# CPU BOARD

149H179

(PCB 052H402A)

## MODIFICATION

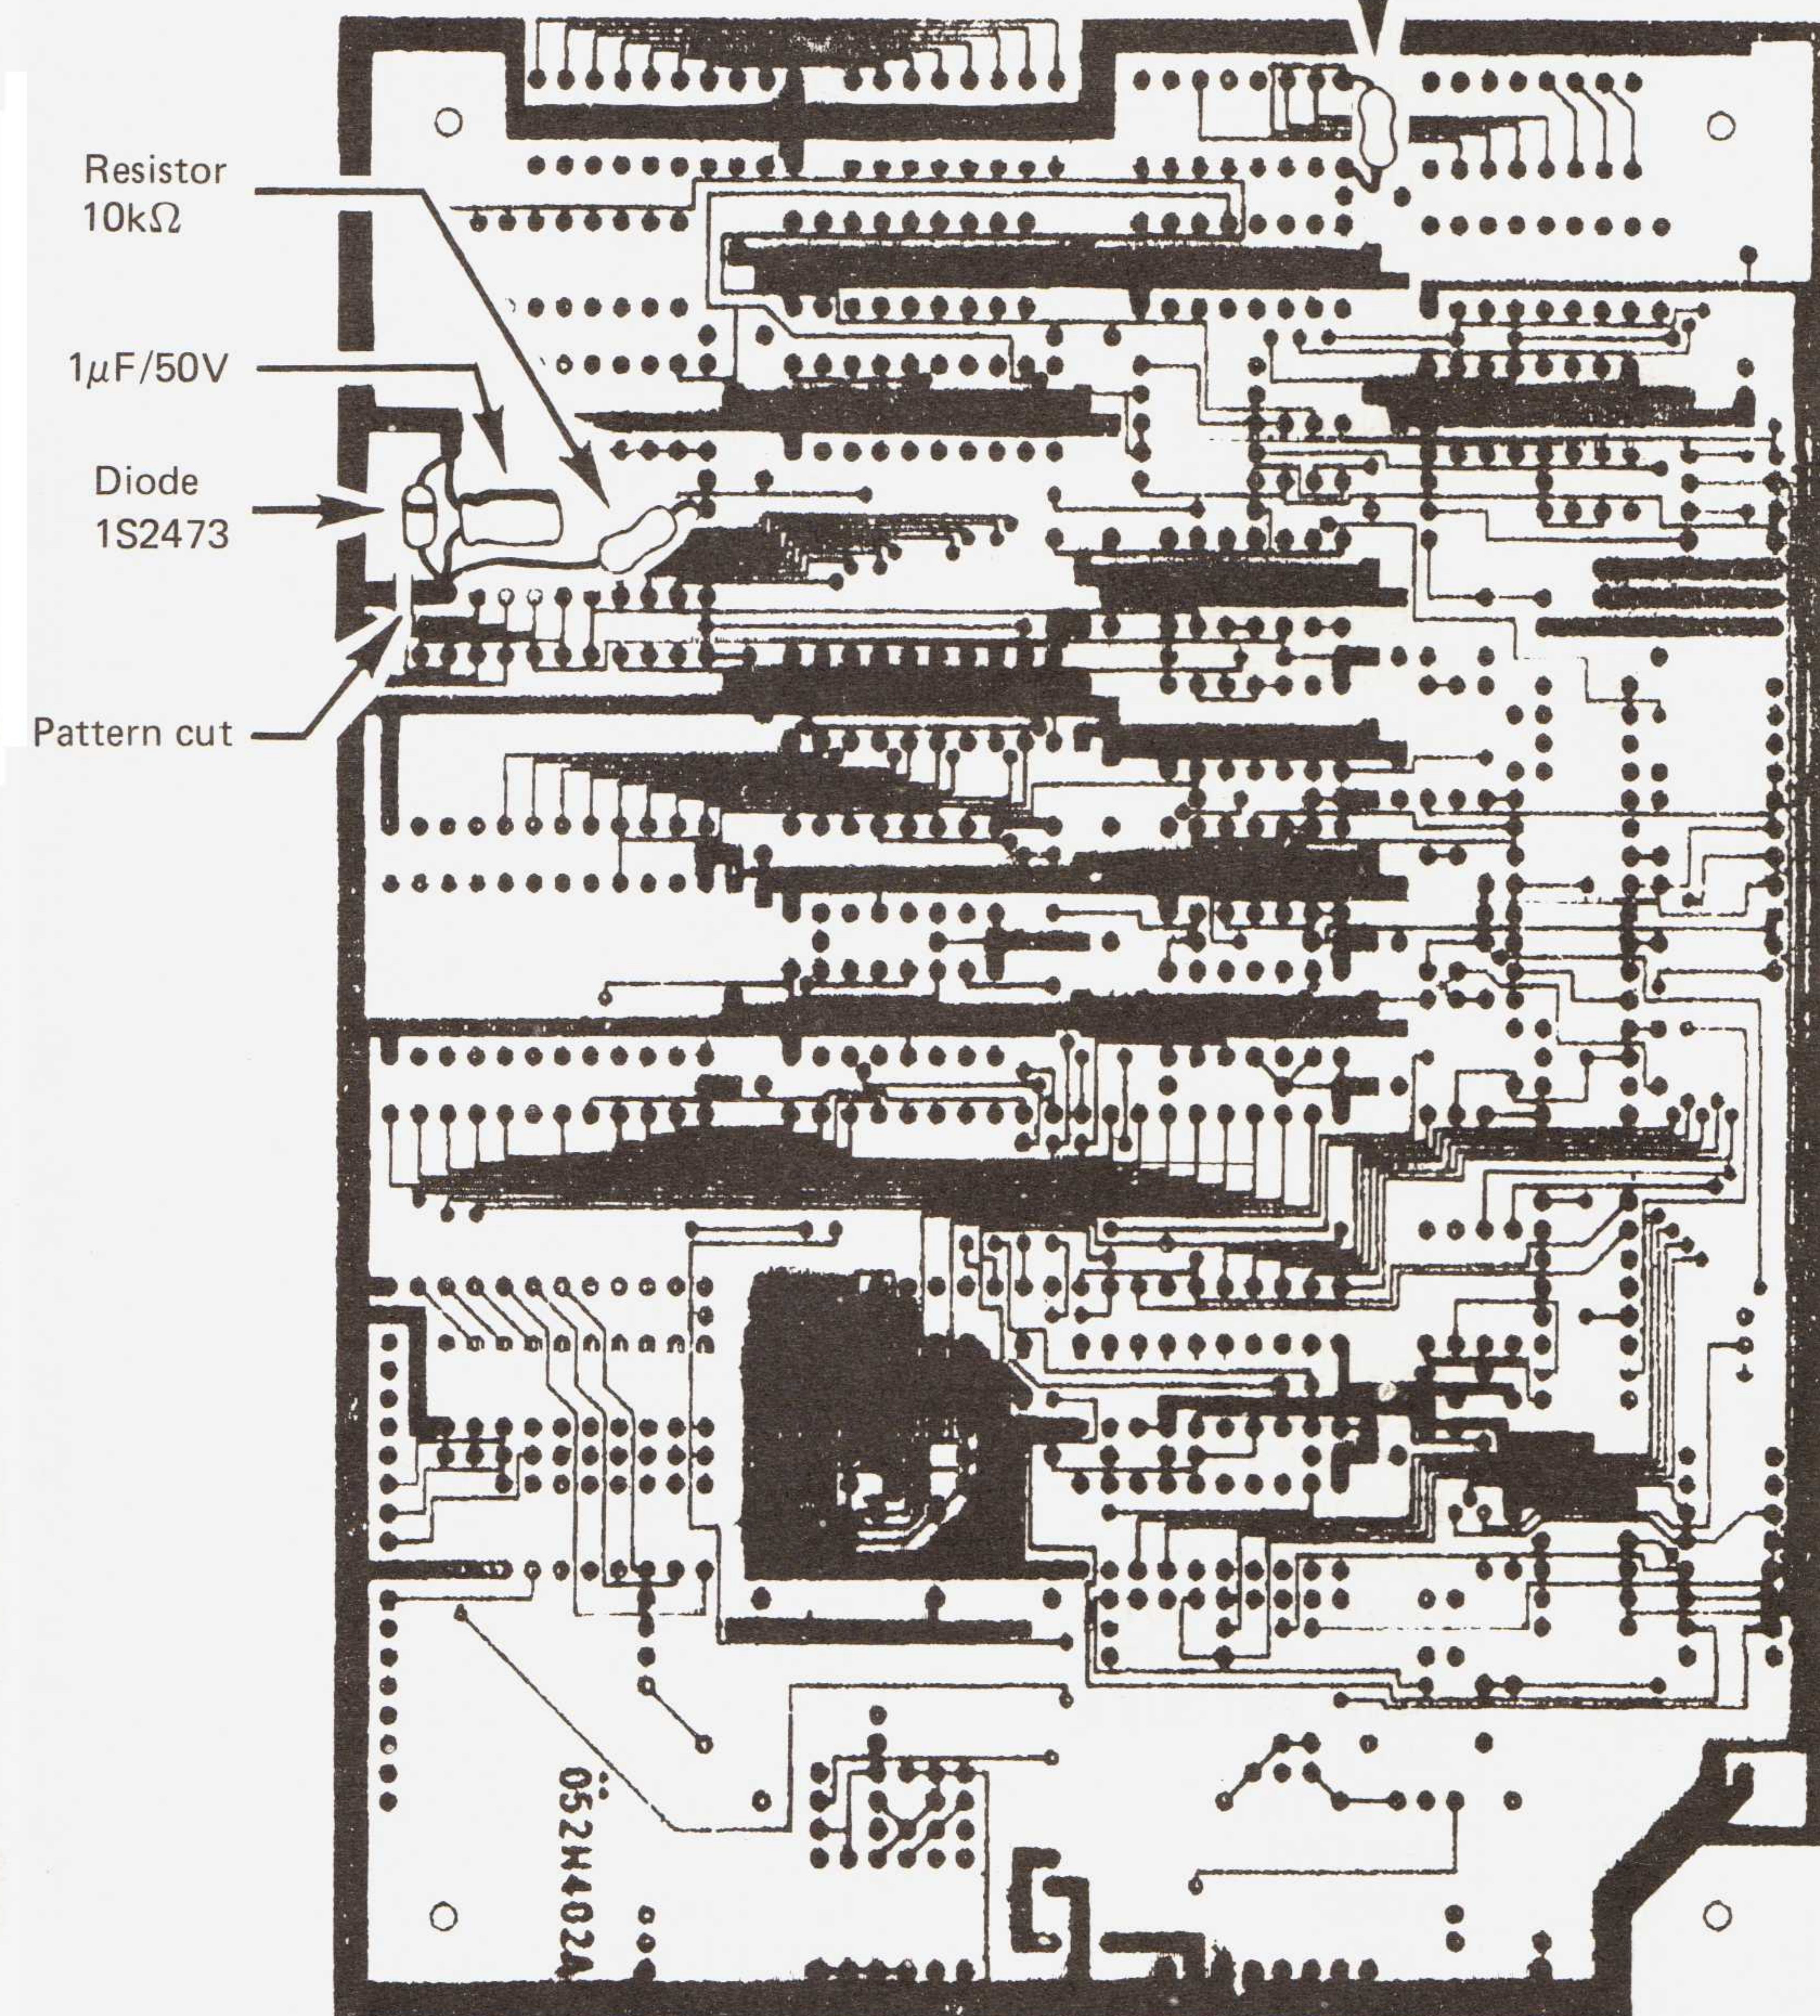
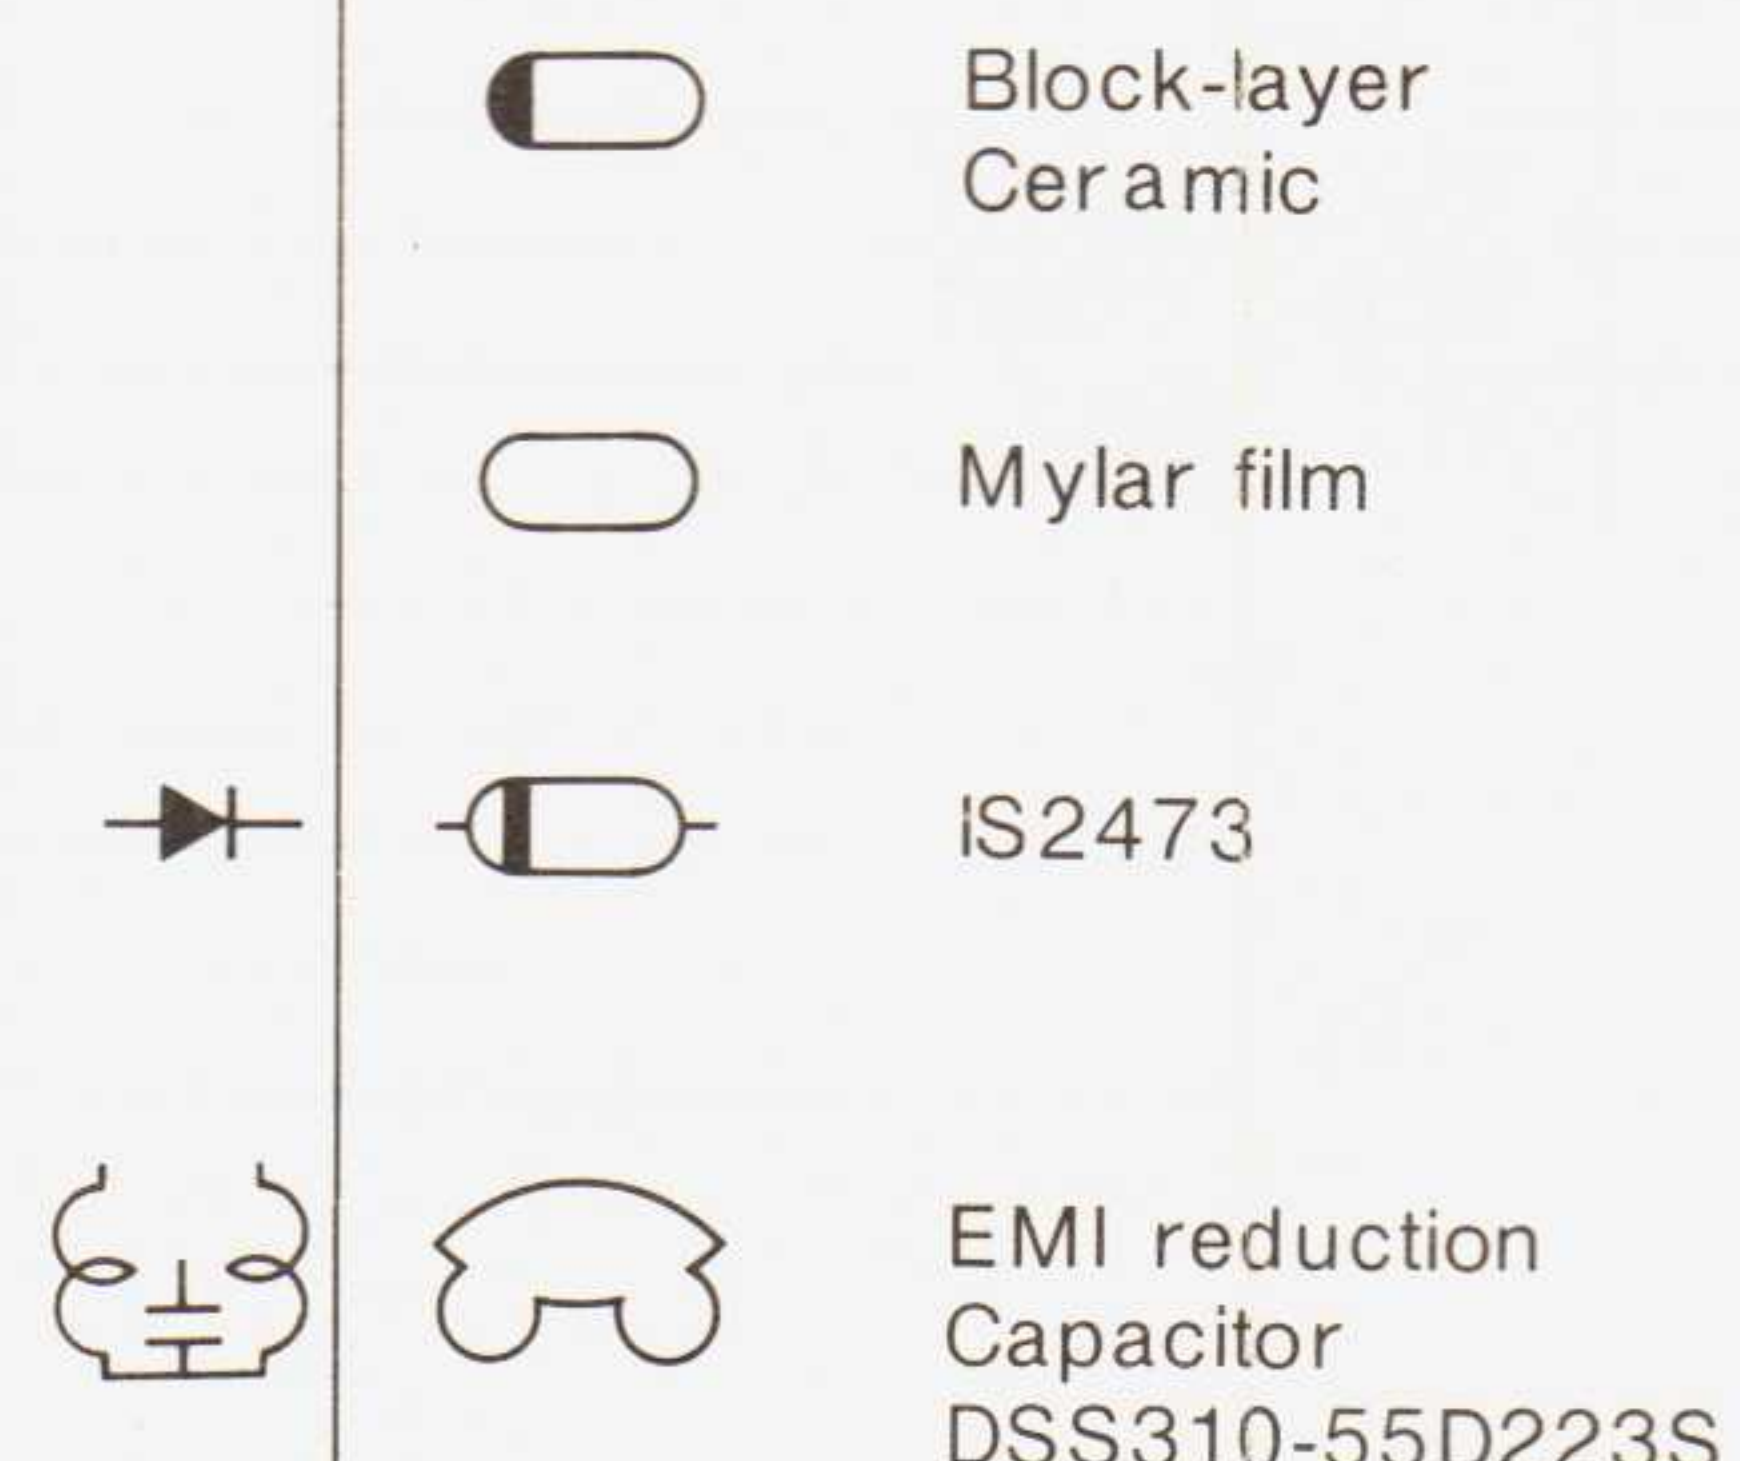
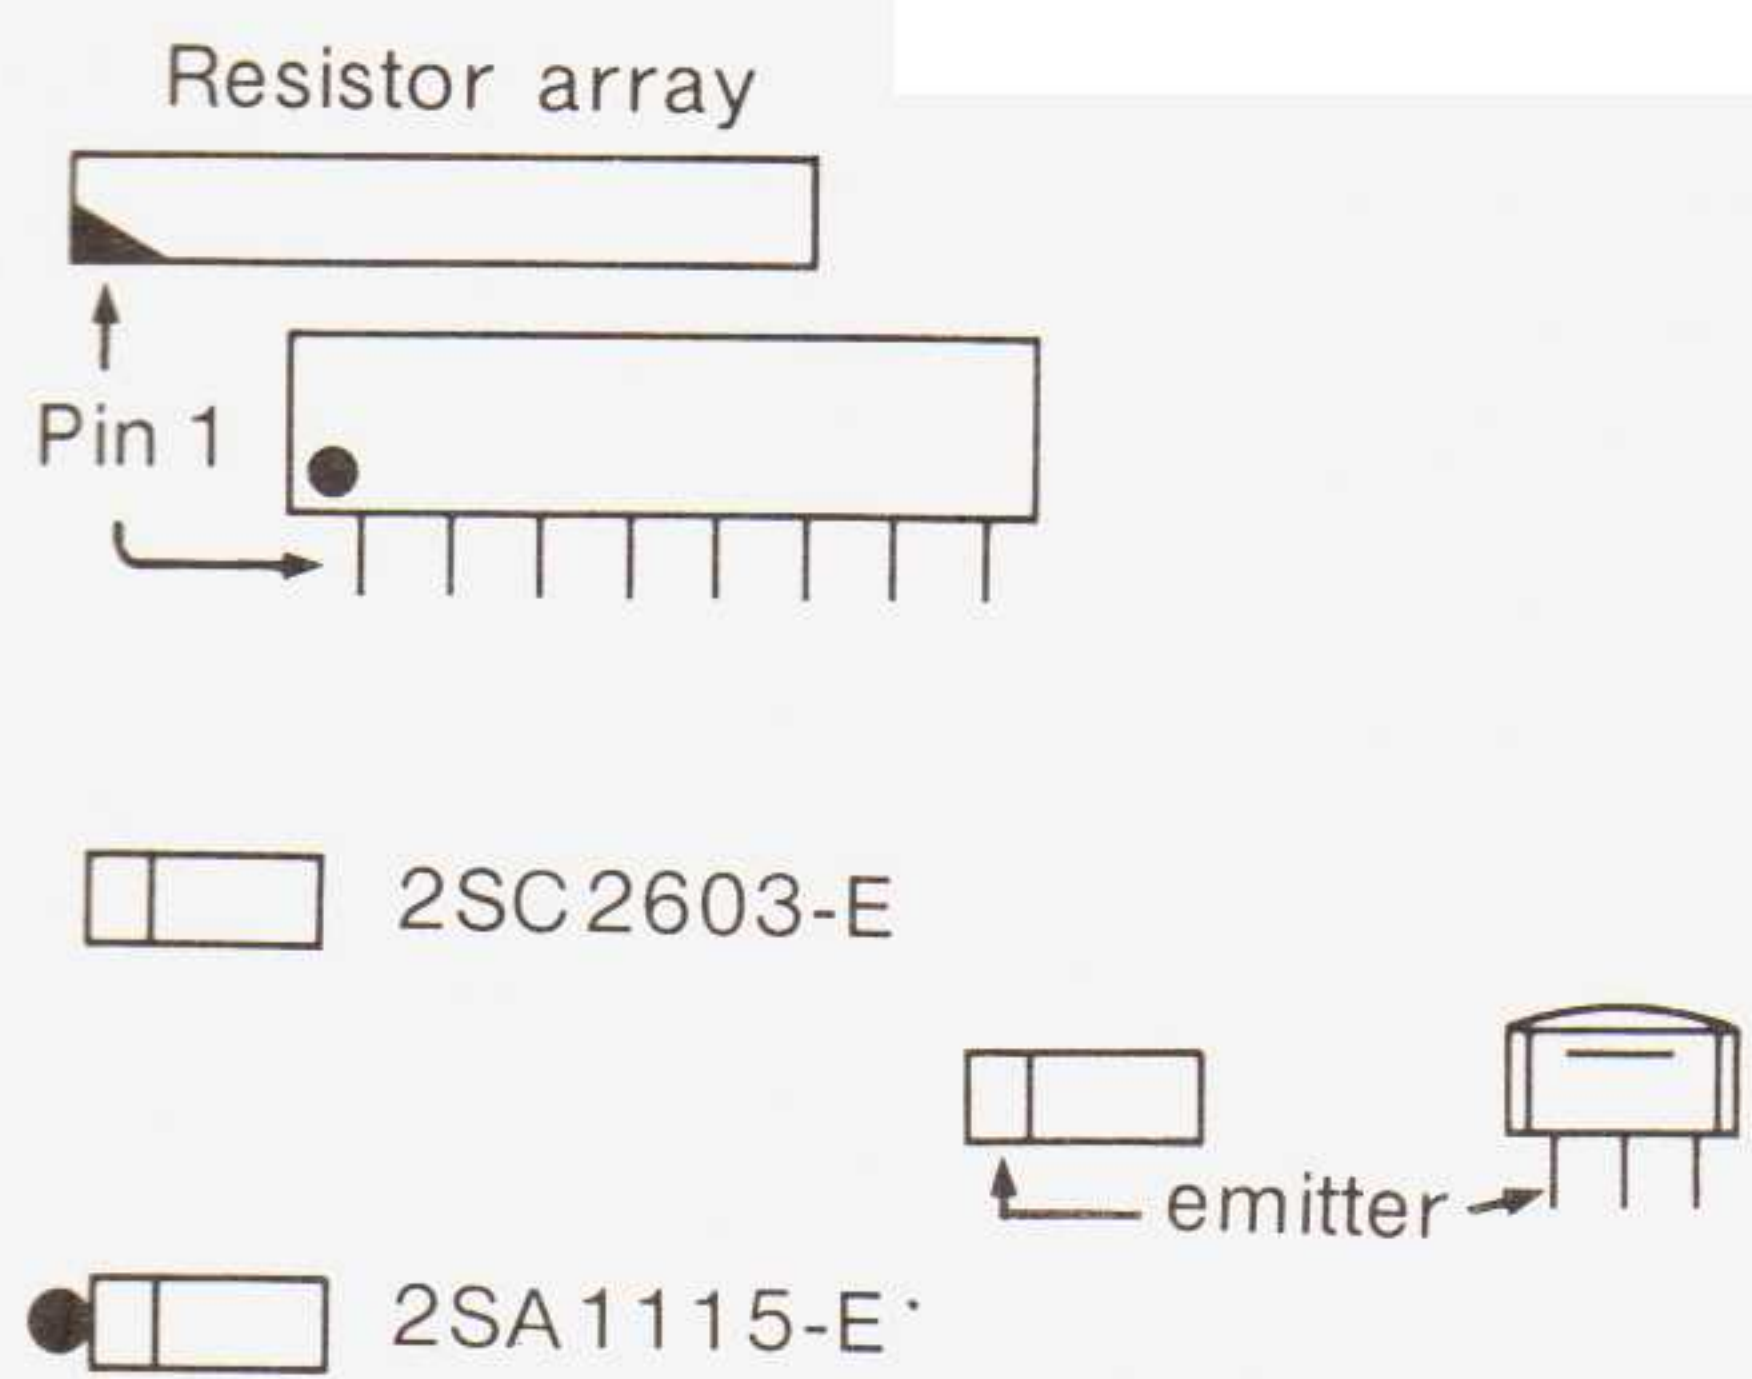
For positive switch scanning in TAPE modes.

See detailed information in PANEL BOARD R

Resistor  $33\Omega$

**View from foil side**

This modification is unnecessary when TR3, R24, R25 and R26 are present on PANEL BOARD R.
